SEWAGE DISPOSAL SYSTEM

P 37184A REPAIR

DATE 6/16/86Jack FyockIS PERMITTED TO INSTALL _____ ALTER XADDRESS _____ PHONE 988-9270SUBDIVISION _____ ROAD 12700 Triadelphia Road LOT _____PROPERTY OWNER Barnett12700 Triadelphia Road

A Repair
P37184

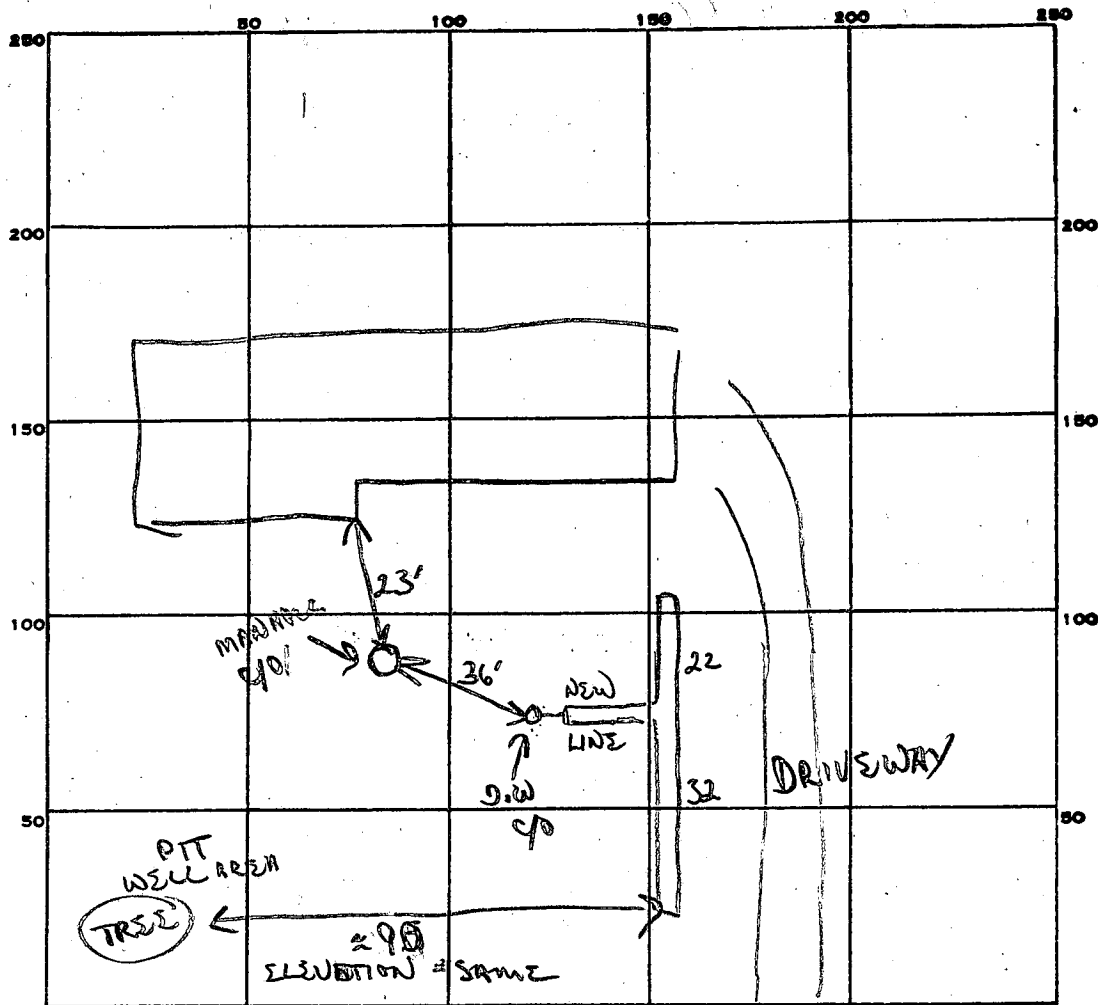
REMARKS (soils predominately silty near loams. 10-15% 2-6" shale fragments ~ 10' down) Tied into existing line at ~5' deep
OK to go 5-12' deep w/ repair. OK to add stone pipe
paper to trench. OK to cover trench & all work

DATE SYSTEM APPROVED 6/27/86 INSPECTOR B. W. Upon

PLOT PLAN

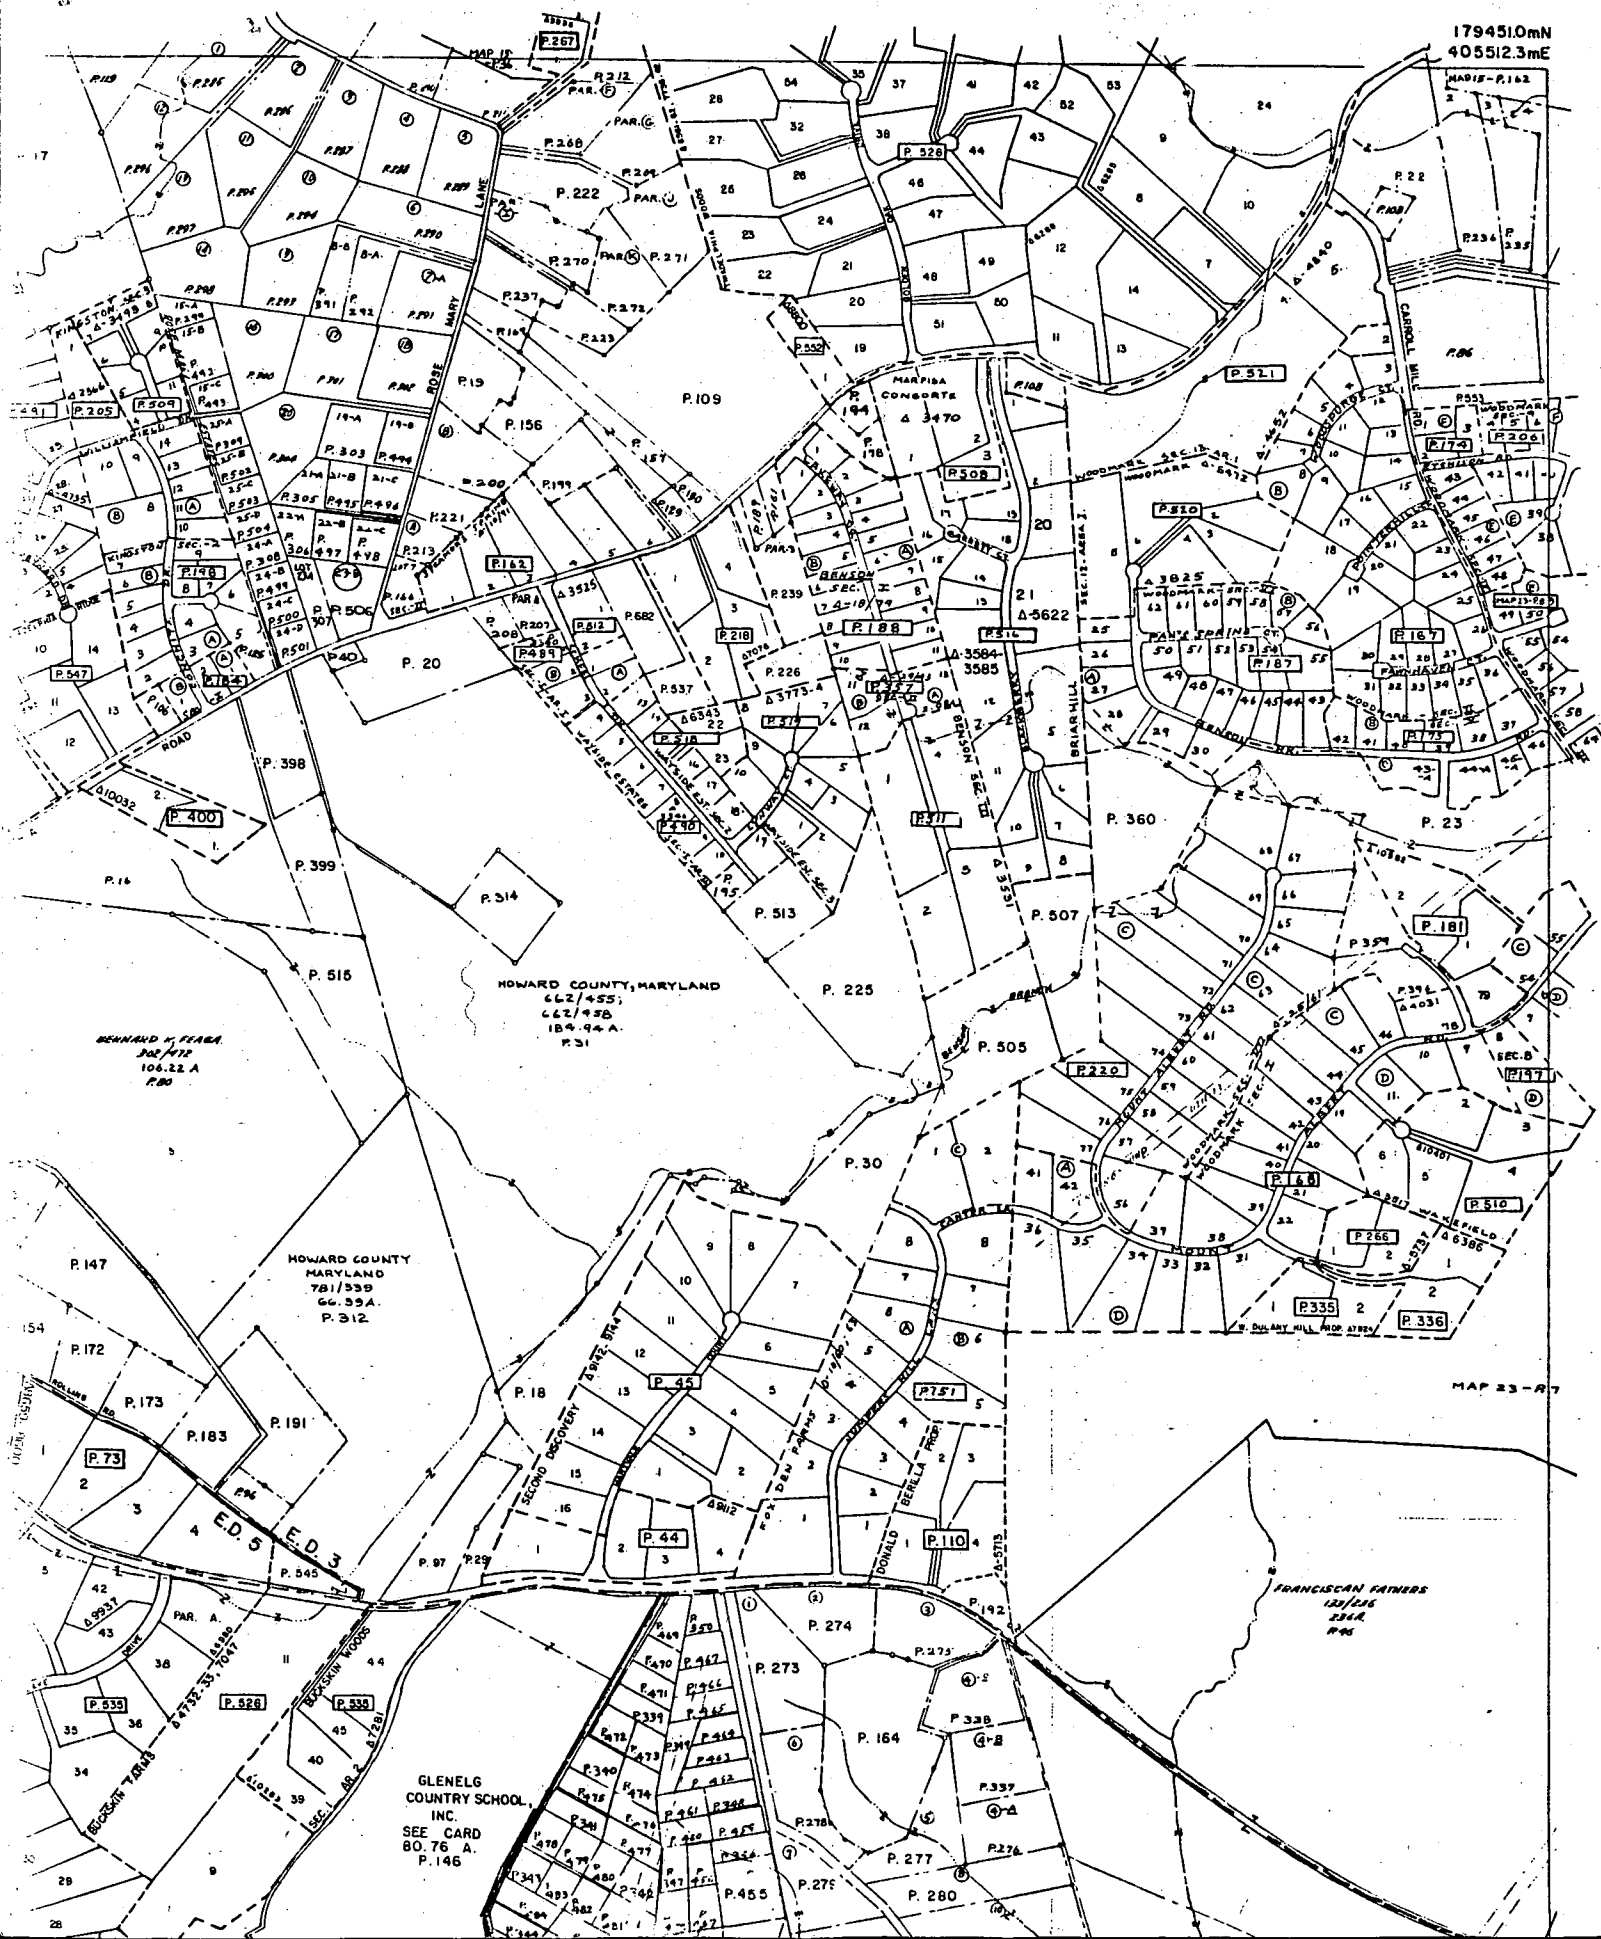
NO IMPACT ON SEPTIC. OK TO PROCEED. 11/7/89 C.W.

No evidence of Septic
problem, Room For
Repairs Doubtful.
Owner Says No Change
in Bedroom Number
Planned, just enlarging
existing rooms.

Recommend Approval
R/P 1/3/94 HD
